UNITED STATES PATENT AND TRADEMARK OFFICE

APPLICATION NO.	FILING DATE	FIRST NAMED INVENTOR	ATTORNEY DOCKET NO.	CONFIRMATION NO.
10/064,590	07/29/2002	Abdelaziz Ikhlef	122667	5121
23413	7590	12/14/2004	EXAMINER	
CANTOR COLBURN, LLP 55 GRIFFIN ROAD SOUTH BLOOMFIELD, CT 06002			SUNG, CHRISTINE	
			ART UNIT	PAPER NUMBER
			2878

Office Action Summary

Response to Amendment

**Fig. 2**

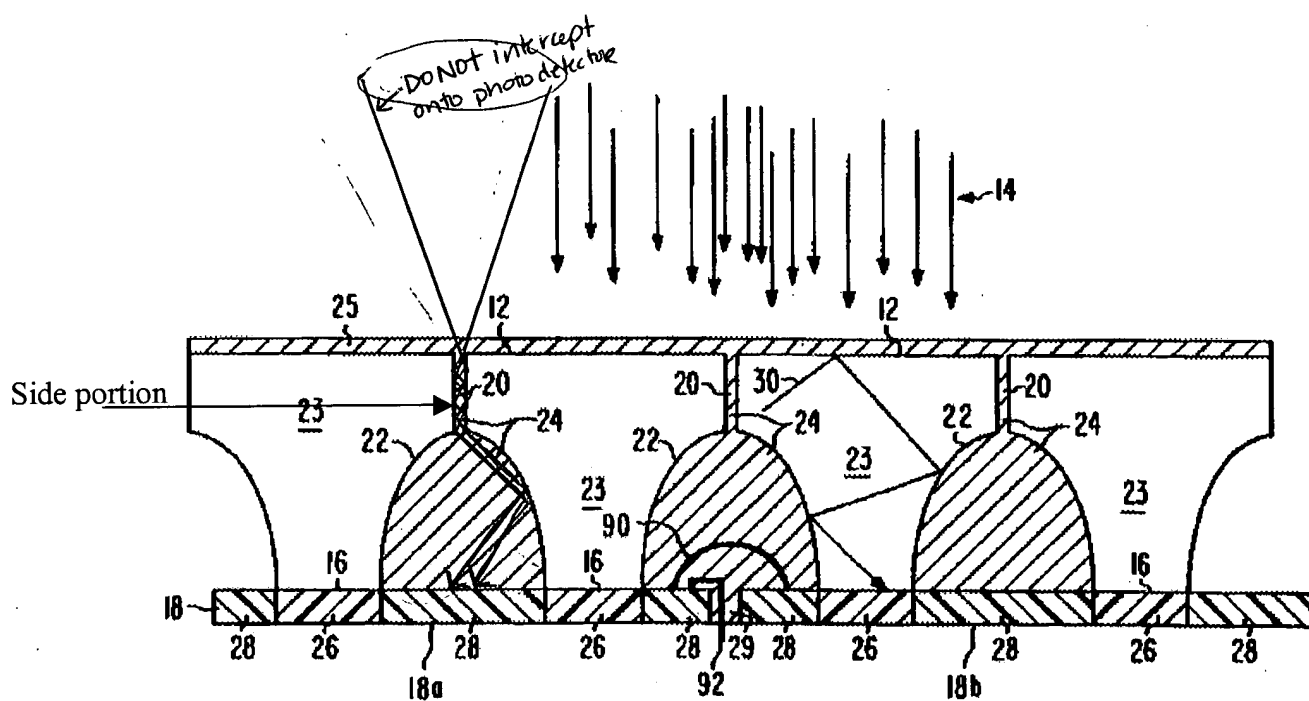
Regarding claim 26, Cueman discloses a scintillator (element 23) and inherently discloses that the scintillator with a side portion (see figure below) configured to reduce sensitivity of a photosensor to a selected focal spot motion. Inherently due to the gap formed between the scintillator and the scintillator positioning, there is a cone of focal points that will not be detected by the photosensor. (see Figure below).

Cueman discloses element 23 with a side surface (see figure below). When radiation impinges upon the grooves formed by elements 20 and 24 the radiation impinges in that area and is not received by the photosensor, element 26. The physical shape of the groove requires that when radiation impinges in that area, it is absorbed by the metallization and does not reach the photosensor. Further the necessary element need not be recognized at the time of invention.

Applicant further argues the fact that the inherent feature may occur or be present in the prior art is not sufficient to establish inherency. However, due to the physical set up of the detector, the side portion of the element 23 is inherently present and further the inherent element need not be recognized at the time of the invention. The physical positioning of the detector

requires that the grooves formed by elements 20 and 24 and the side portion of the scintillation element 23 to prevent impingement of radiation that enters that groove to hit the photosensor.
